**Written submission from the  
Métis Nation-Saskatchewan**

Application for licence amendment  
for the expansion of the JEB Tailings  
Management Facility (TMF) at the  
McClellan Lake Operation

Re: Orano McClean Lake TMF Licence Amendment Application: Written Intervention from the Métis Nation of Saskatchewan (CMD: CMD 21-H6.1)

**Orano McClean Lake TMF  
Licence Amendment  
Application Review**

Figure of cross section of TMF [Figure 4.1-1, Project Description, Orano, October 2019]

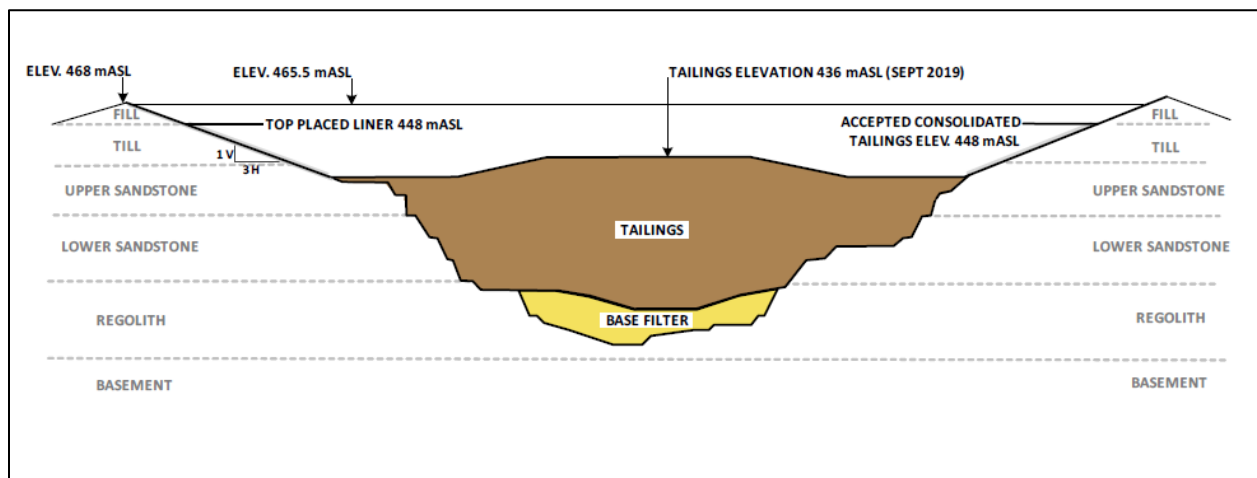
“The proposed JEB TMF expansion will result in the toe of the embankment being 10 m from the high-water mark of Fox Lake, which will provide the minimum buffer necessary to minimize impacts to the lake.” [pg.18]

- It does not appear that climate change scenarios, specifically water level rising and normalized flood events, were considered with respect to the distance to Fox Lake. This 10 m set back also appears to be the minimum buffer to meet legislative requirements. Suggest that this set back be increased.

**Figure 6.21.1 Selenium Concentrations at the JEB WTP Final Discharge Point (CM01B)**

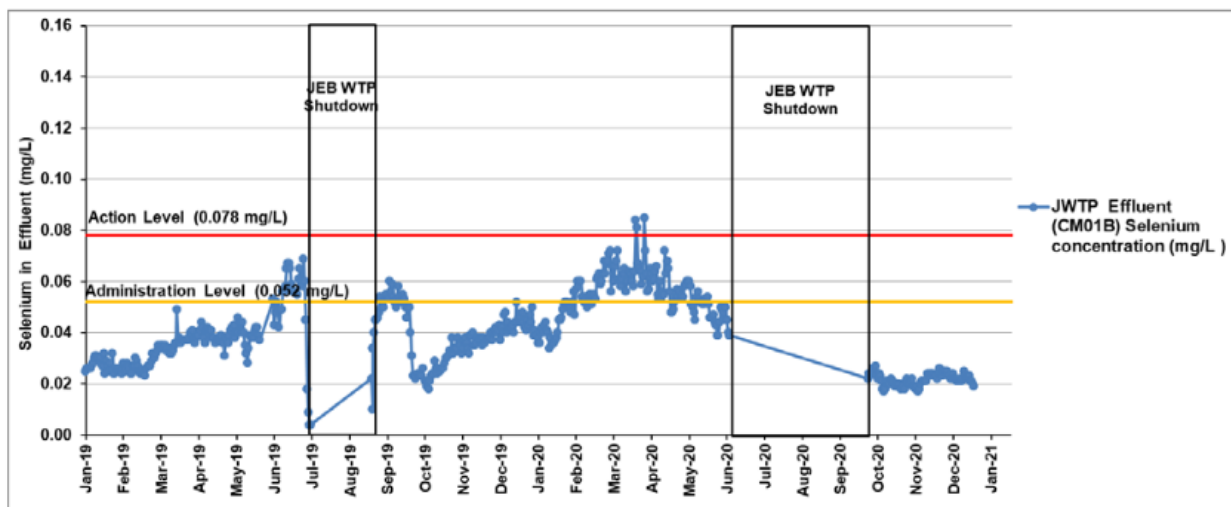
The risk of Se has been raised in several hearing submissions and EA's conducted for McClean Lake licencing. For example, the Ya'thi Néné Land and Resource Office Submission (November 13th, 2018).

Orano is required to report on the performance of their Selenium Adaptive Treatment Plan, and (see section 6.21.1 of the 2020 McClean Lake Operation Annual Report). They report that in March 2020 the Se concentration exceeded the "action level", and on several additional occasions throughout 2019-2020 it exceeded the "administrative level". The report states that COVID-19 played a factor in these exceedances.

The CNSC has reviewed the Se risk assessment and determined that Orano’s mitigation plans were sufficient. (Section 3.2.3. pg 19, Environmental Protection Review Report, CNSC, June 2021)
